1039 Spaight  
Certificate of Appropriateness  
September 18, 2023

# Proposed Work

- Construct an enclosed porch above attached garage on side of house

PROPOSED PLAN  
1/4" IN = 1' FT

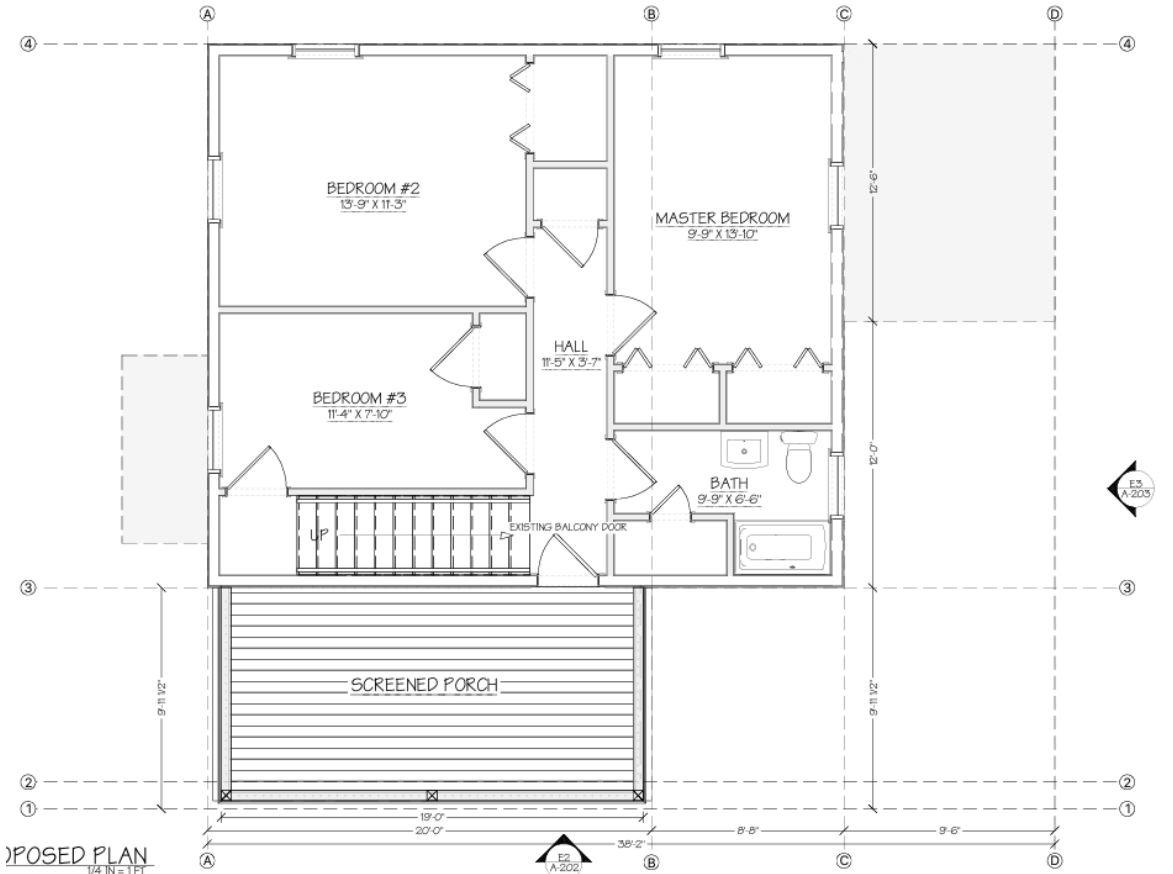
Staff believes that the standards for granting a Certificate of Appropriateness could be met and recommends the Landmarks Commission approve the project with the following conditions:

1. Final specifications for the railing be approved by staff.
